THE CITY OF ROCKFORD ILLINOIS, USA

ADDENDUM TO BID
RECONSTRUCTION OF AIRPORT DRIVE AND FALCON ROAD
BID NO.: 814-PW-113
EDA AWARD NO.: 06-01-05752

ADDENDUM NO.: 1

Add Gate and Fence Details

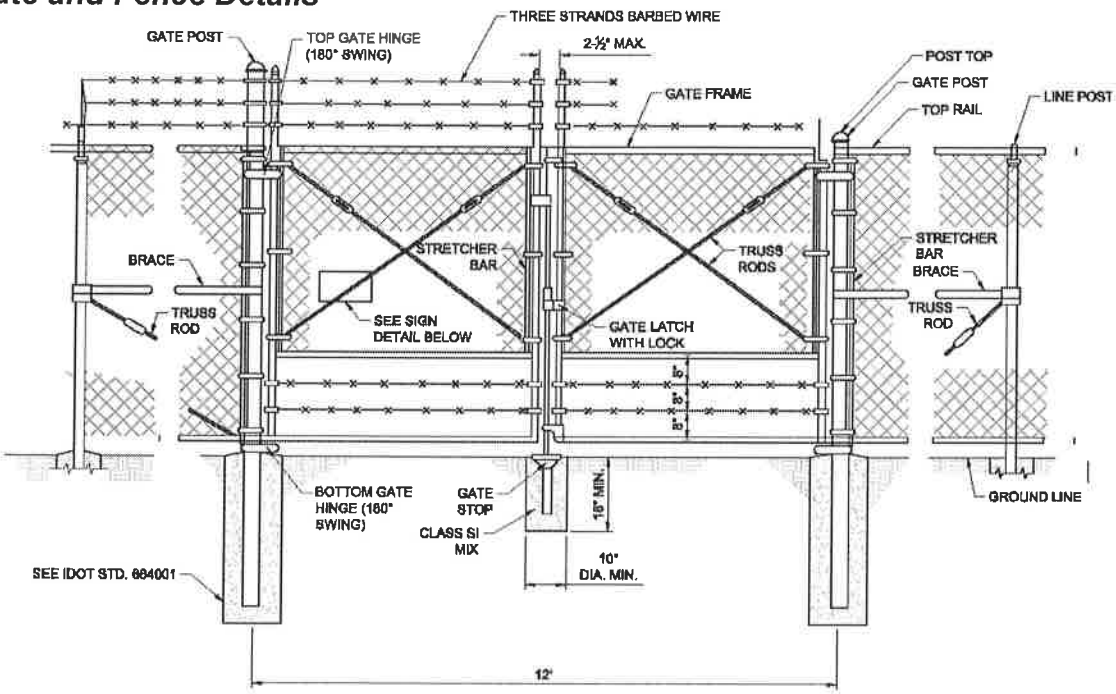
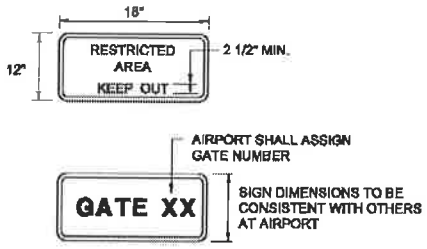
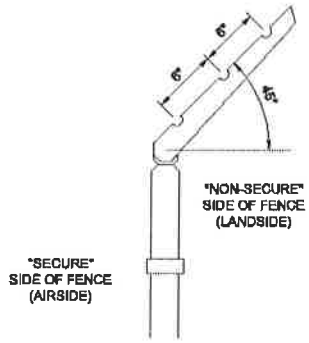
The double swing gate will be paid for as one unit per each 12' wide opening. Each swing gate will not be paid for separately.

MAINTENANCE OF TRAFFIC -
DRIVEWAY SIGN DETAIL

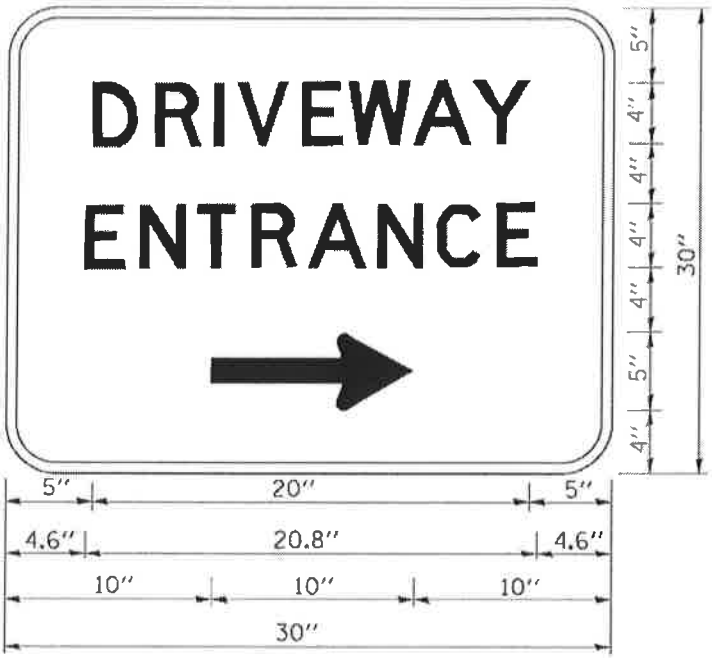
Add to Maintenance of Traffic - Driveway Sign Detail

CONSTRUCTION EQUIPMENT AND TRUCK/VEHICLE SIGNAL FLAG

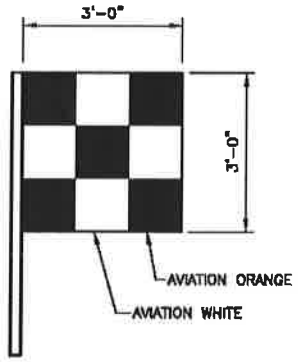
Add to Maintenance of Traffic - Airport General Notes and Detail
